Hurricane Planning Commission Meeting Agenda

1. FSP23-68: Discussion and consideration of a possible approval of a final site plan for Buck's Ace Hardware, a commercial subdivision located at 1400 W 100 S. Buck Hurst, Applicant. Tyler Hughes, Agent.

STAFF COMMENTS

Agenda Date:	01/03/2024
Application Number:	FSP23-68
Type of Application:	Final Site Plan Application
Action Type:	Administrative
Applicant:	Buck's Ace Hardware
Agent:	Tyler Hughes
Request:	Approval of a Final Site Plan
Location:	1400 W 100 S
Zoning:	HC
General Plan Map:	Commercial

1 NORTH ELEVATION
1/8" = 1'-0"

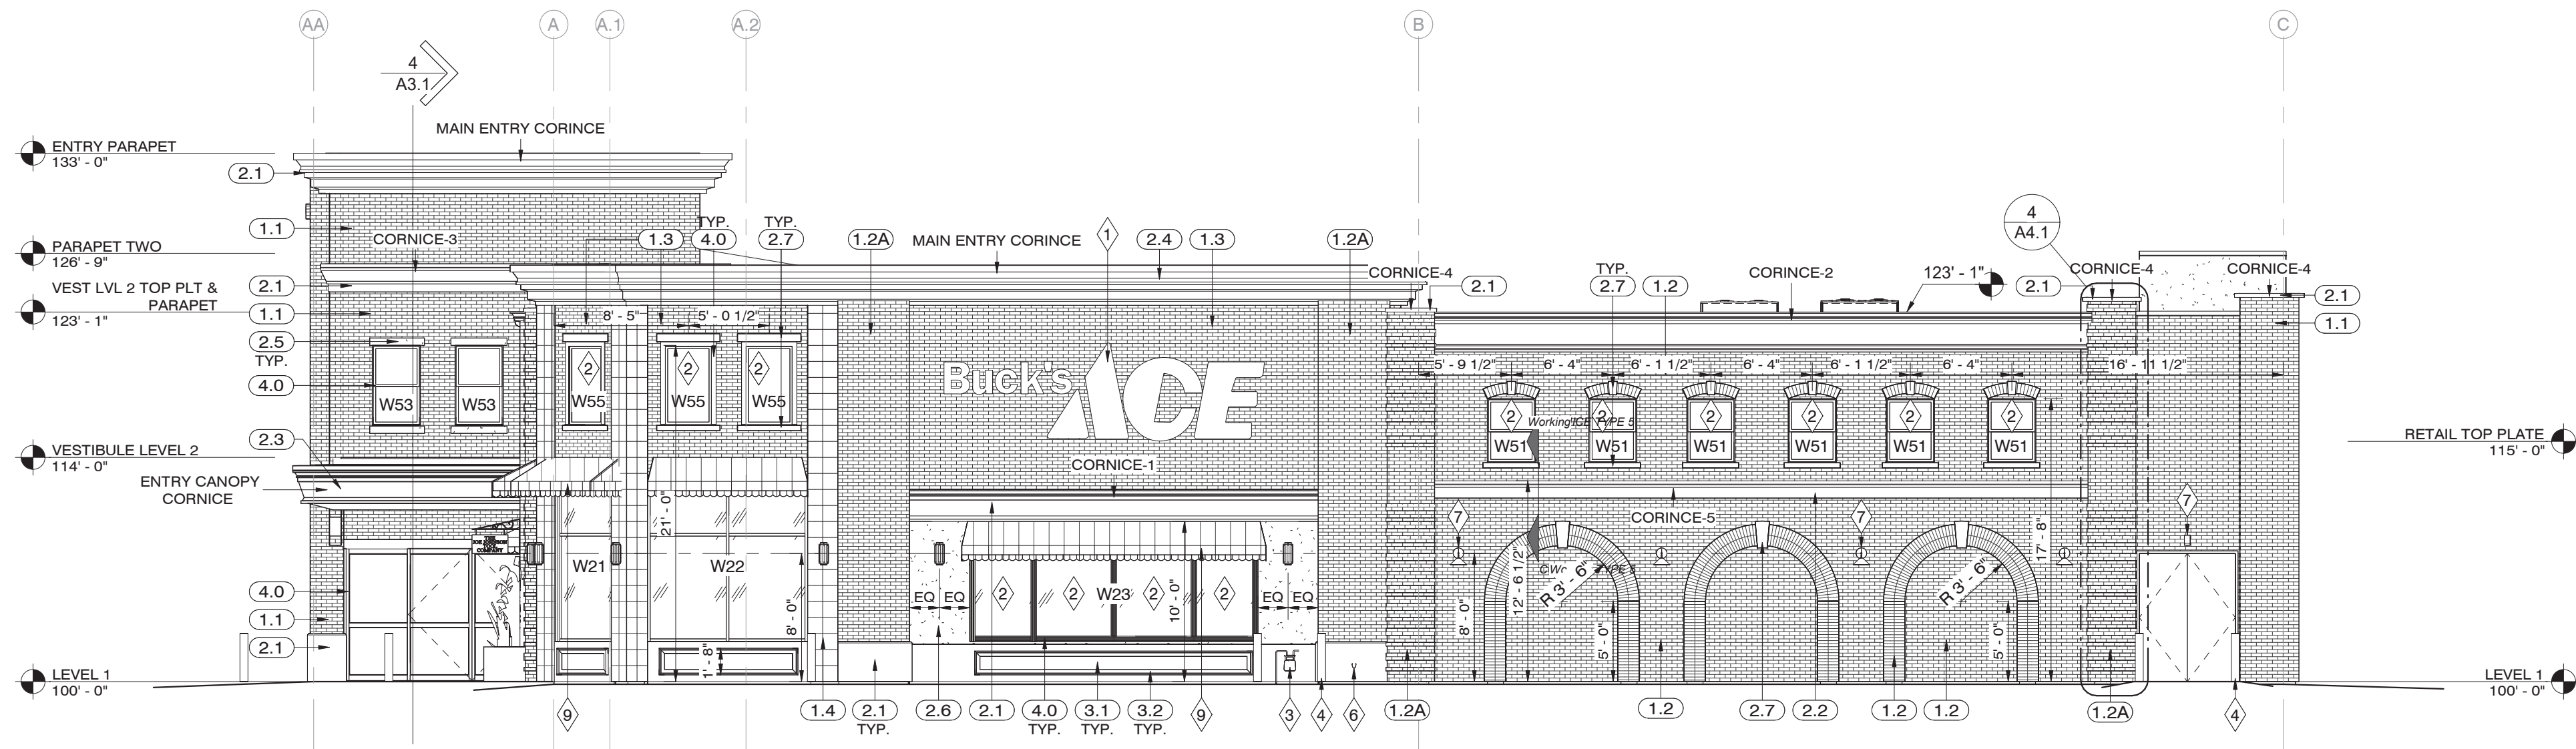
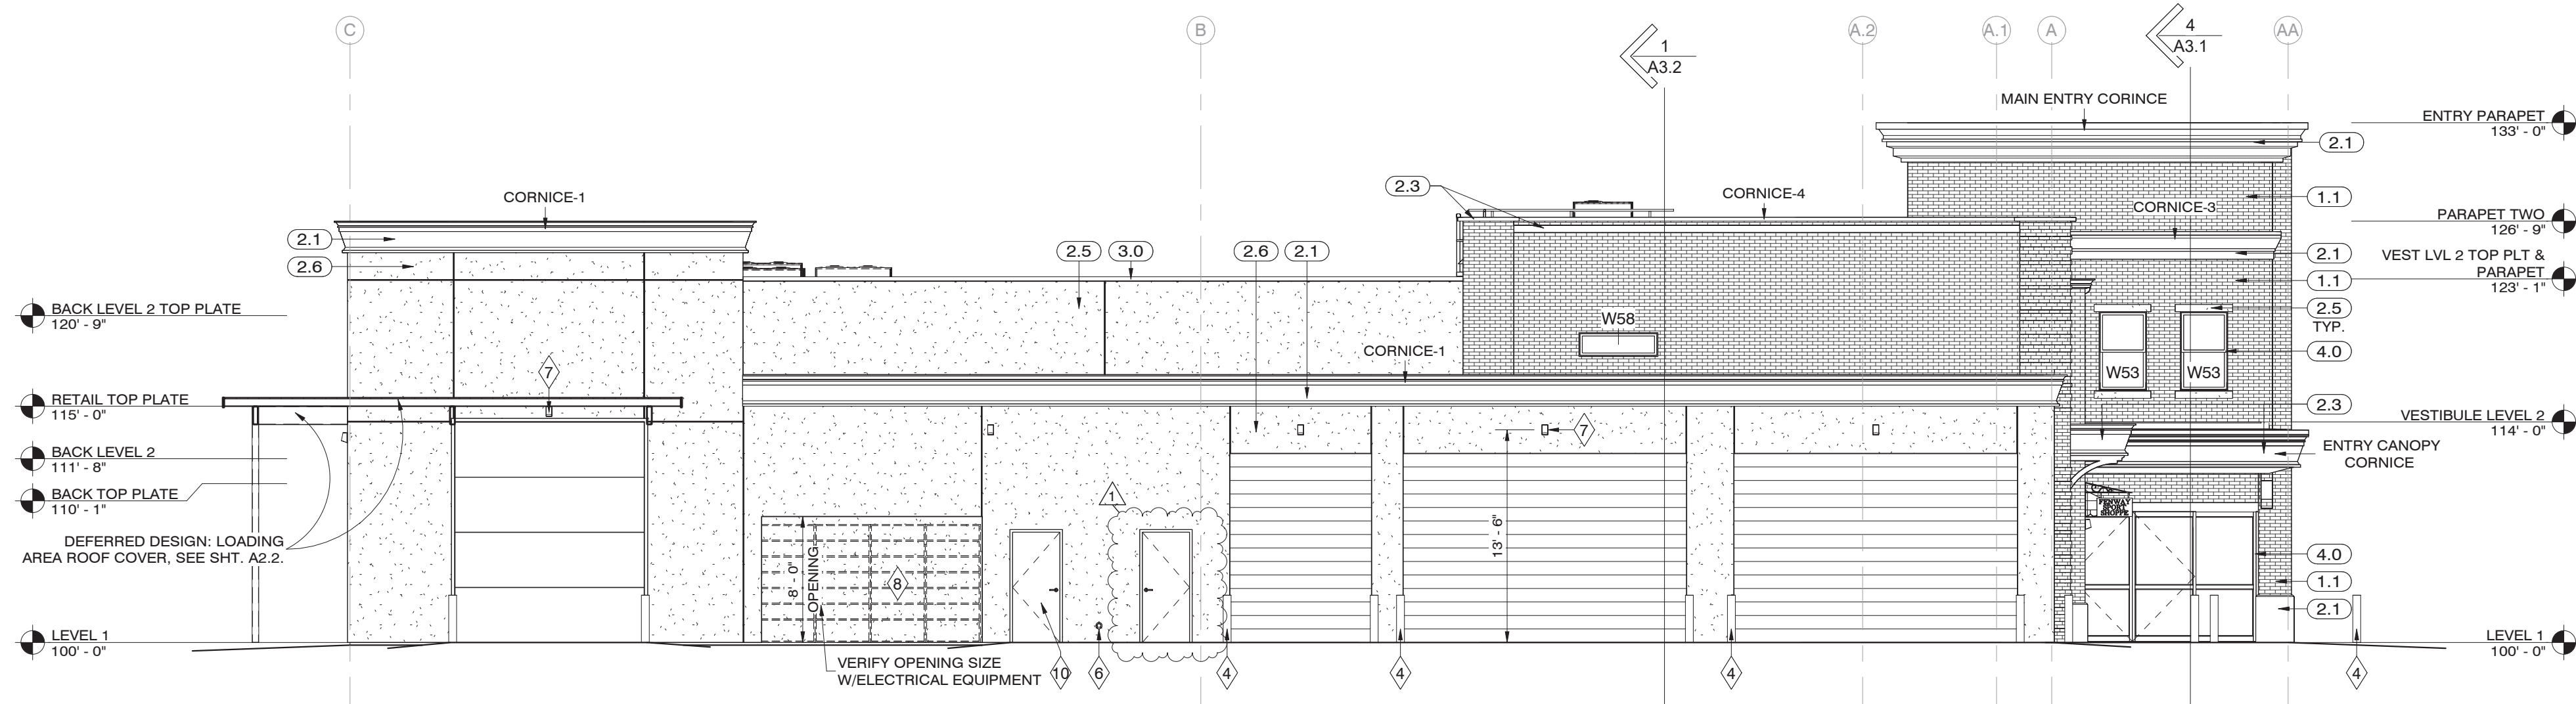
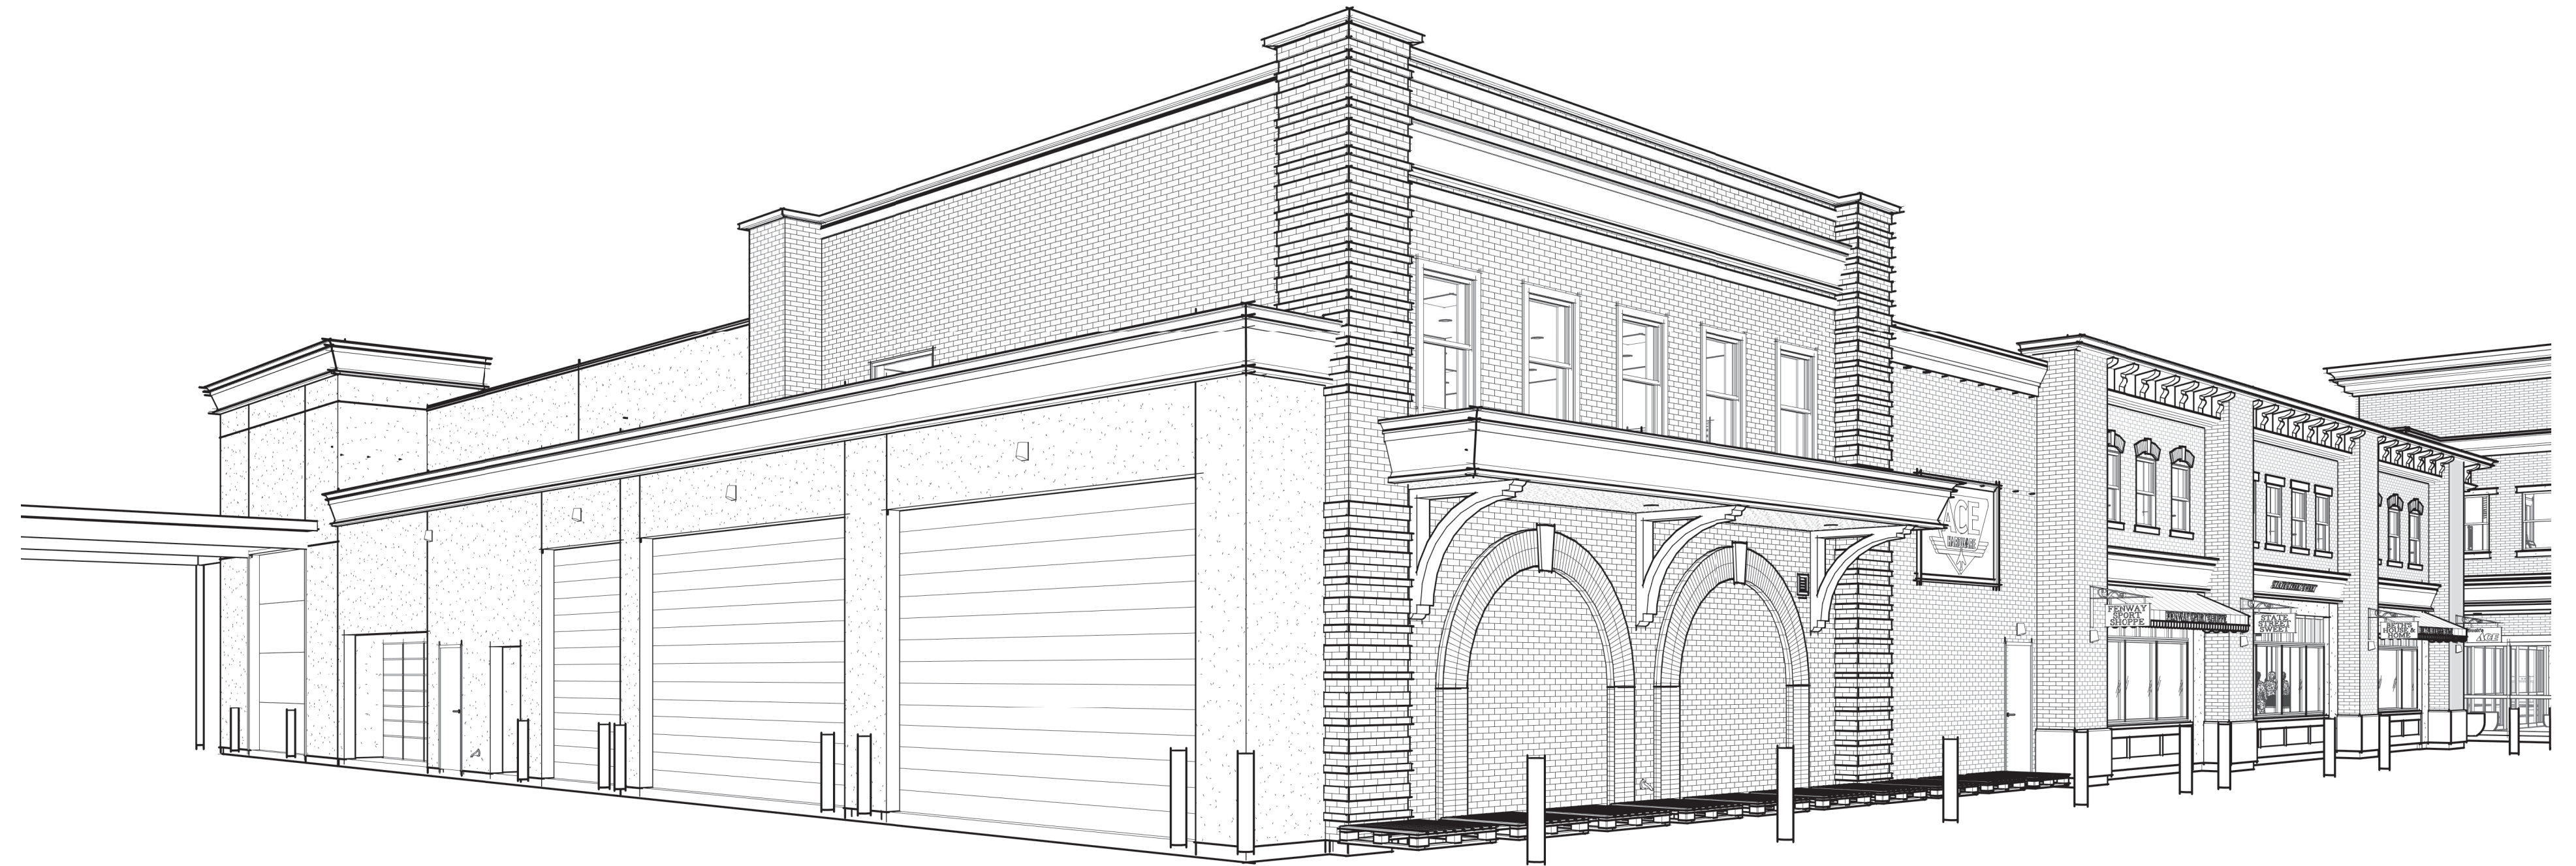
- 7. The applicant has provided building elevations and renders and the building is not taller than 35' as required by code.
